MFN 08-322

Docket No. 52-010

Subject: Consolidated RAI Responses and DCD Appendix 3L Revisions
Related to ESBWR Steam Dryer

**Listing of Consolidated Requests for Additional
Information Responses Related to ESBWR Design
Certification Application for ESBWR Steam Dryer**

Figure 3L-1. Typical Chimney and Partition Assembly

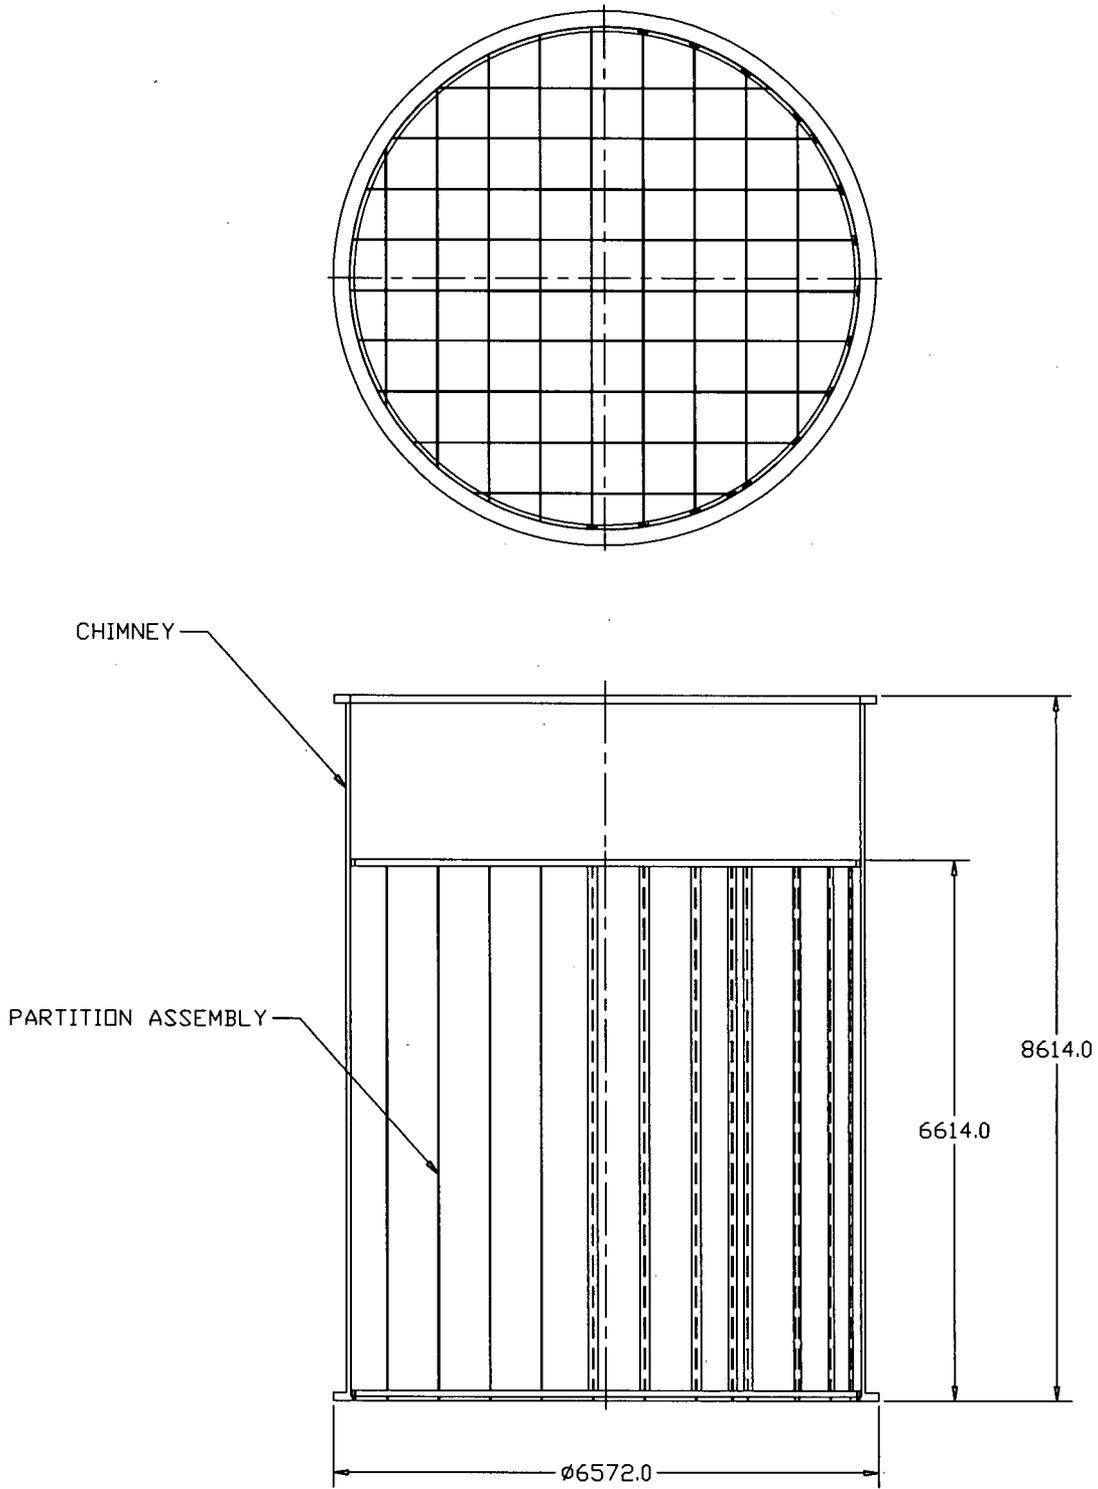
The chimney ~~partition~~ assembly design consists of a chimney shell and partition assembly. The chimney shell has a bottom ring of the partition assembly that rests on and is bolted and pinned to the top guide, see Figure 3.9-8. The chimney partitions rest on the bottom flange of the chimney shell. The top ring of the partition assembly is supported against the inside of the chimney shell. The ~~partitions~~ partition assembly is a grid of square structures, each of which encompasses and lines up with 4 top guide fuel cells (i.e., 16 fuel assemblies). The chimney shell and partitions are fabricated using austenitic stainless steel plate, see Table 4.5-1. The partitions that are full length welded at near the junctions of the partitions. ~~The austenitic stainless steel material has a 0.02% maximum carbon content to resist Intergranular Stress Corrosion Cracking (IGSCC).~~ The chimney structure shell that houses the partition structure is cylindrical, similar to the core shroud. A sketch of the chimney and partition assembly is shown in Figure 3L-1. Because the chimney shell has structural characteristics similar to the shroud, this component is considered under the generic reactor internals vibration program, and the partition assembly is considered to be the unique component that requires special vibration consideration.

Figure 3L-2. Typical ESBWR Steam Dryer Assembly

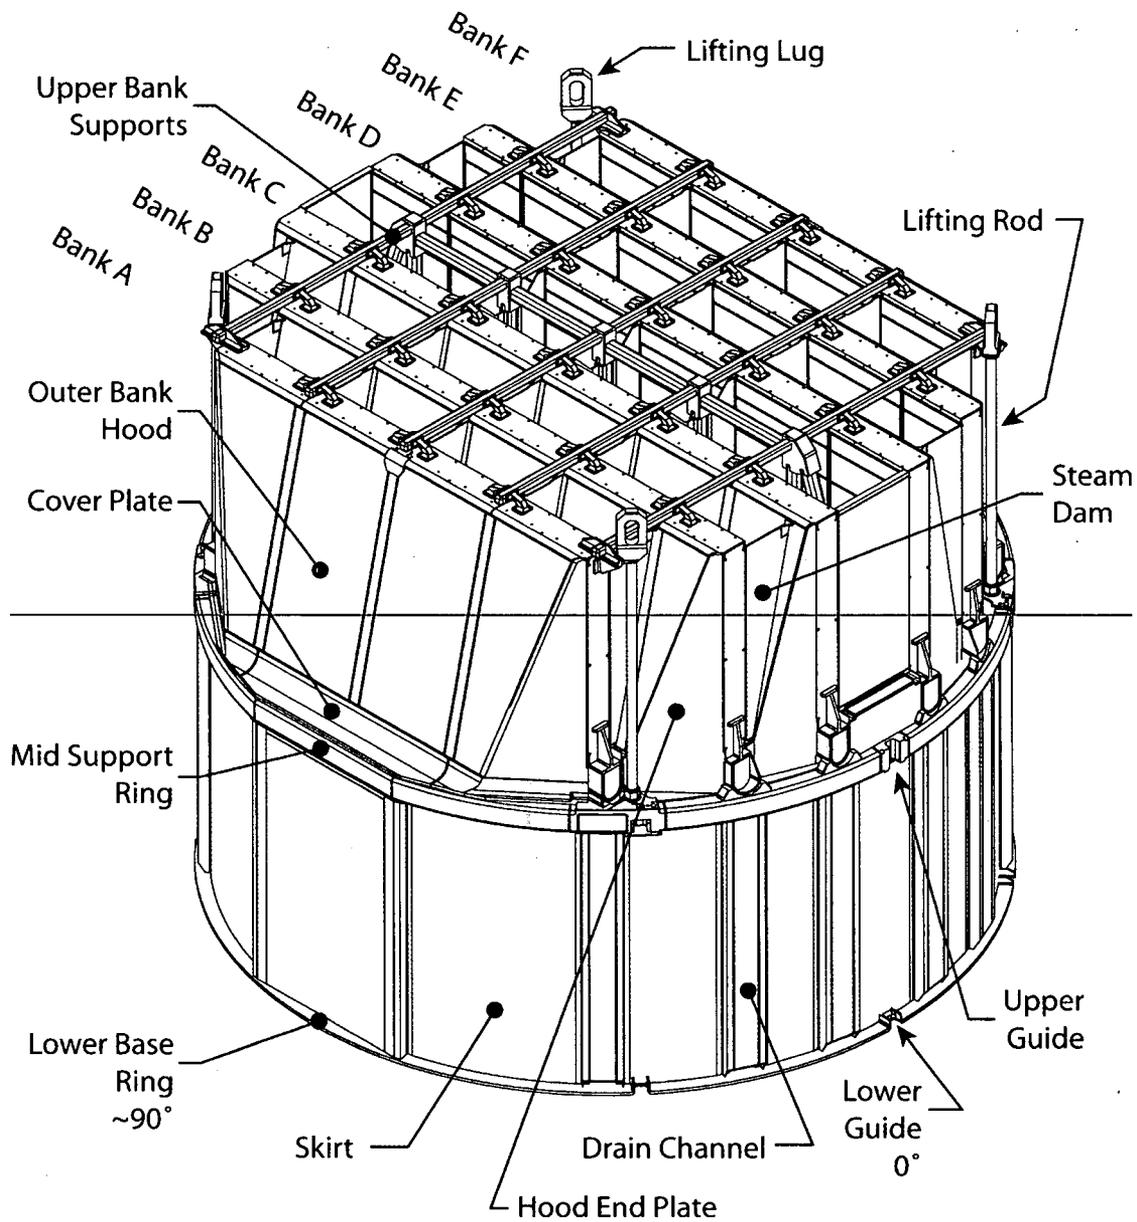
The ESBWR steam dryer consists of a center support ring with dryer banks on top and a skirt below. ~~is designed using modules of dryer vanes enclosed in a housing to make up the steam dryer assembly.~~ A typical steam dryer is shown in Figure 3L-2. ~~The modules or subassemblies of dryer vanes, called dryer units, made up of steam drying vanes and perforated plates, are arranged in six parallel rows called dryer banks.~~ The ESBWR steam flow rate is approximately 15% higher than ABWR. ~~The ESBWR RPV has a larger inner diameter at the vessel flange than ABWR, which will allow dryer banks to be extended, thereby accommodating the higher steam flow.~~ The additional dryer unit face area will result in approximately the same flow velocity through the drying vanes as ABWR and help maintain moisture removal performance requirements. ~~The dryer banks are attached to an upper support ring, which is supported by RPV steam dryer support brackets, that are welded attachments to the reactor pressure vessel (RPV).~~ The steam dryer assembly does not physically connect to the ~~shroud chimney head and steam separator assembly, and does not have a direct connection with the core support or shroud.~~ A ~~The~~ cylindrical skirt attaches to the upper support ring and will project downward to form a water seal around the array of steam separators. Normal operating water level is approximately mid-height on the steam dryer skirt.
